Applicant : Nikolai N. Issaev
Serial No. : 10/719,014
Filed : November 24, 2003
Page : 11 of 15

Amendments to the Drawings:

Page 2 of 2
Appl. No.: 10/719,014
Amendment in Reply to Office action of January 8, 2007
Annotated Sheet Showing Change(s)

FIG. 2

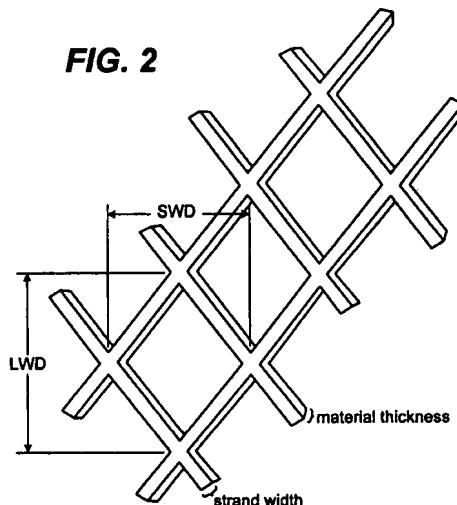
In Figure 2, the metal grid drawing was extended to show an array of diamond-shaped openings.

Applicants amended the specification to state that the grid shown in Figure 2 includes an array of diamond-shaped openings. Support for the amendment to the specification can be found in Figure 2, which shows a grid with an array of diamond-shaped openings.
